SCIENCE BUILDING

LOS MEDANOS COLLEGE

DSA SUBMITTAL DOCUMENTS
NOVEMBER 15, 2004

SCIENCE BUILDING
LOS MEDANOS COLLEGE
Contra Costa Community College District

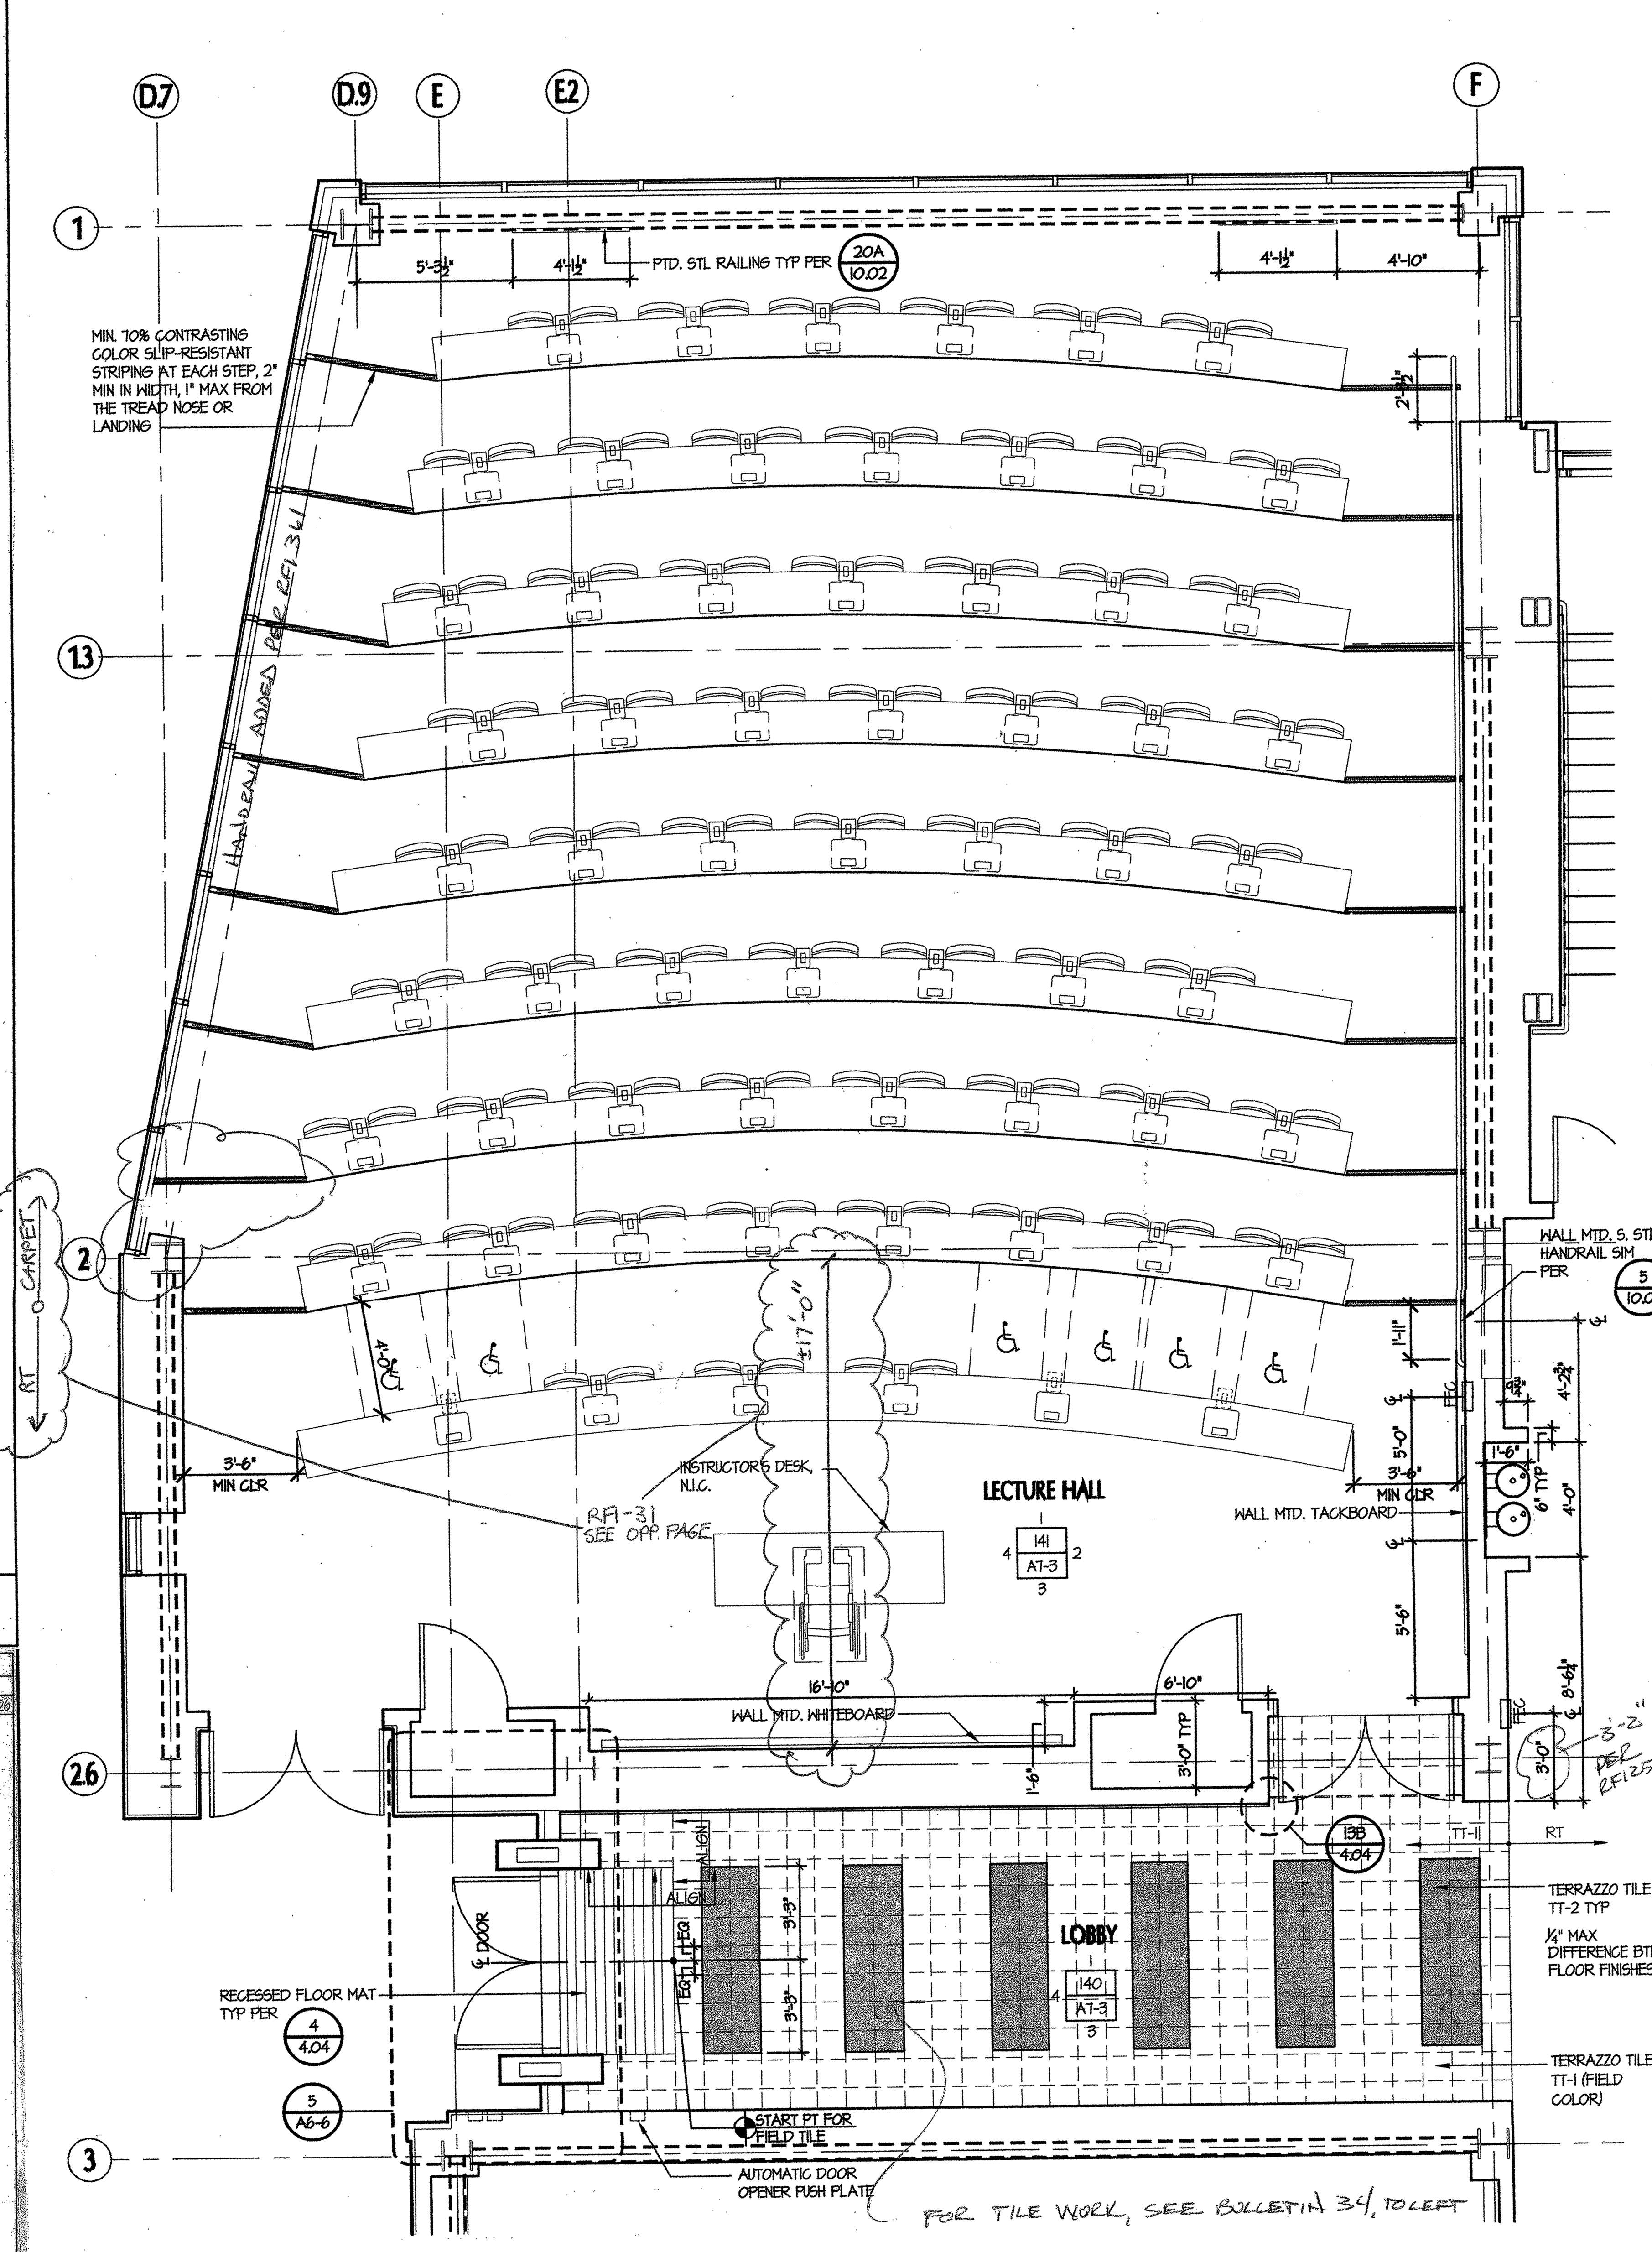
a. At Lecture Hall 141 on 6/A8-5, rubber sheet flooring RT-2 will extend to the first raised tier of seating. The remaining tiered seating north of grid line 2 is carpet tile CPT-1.
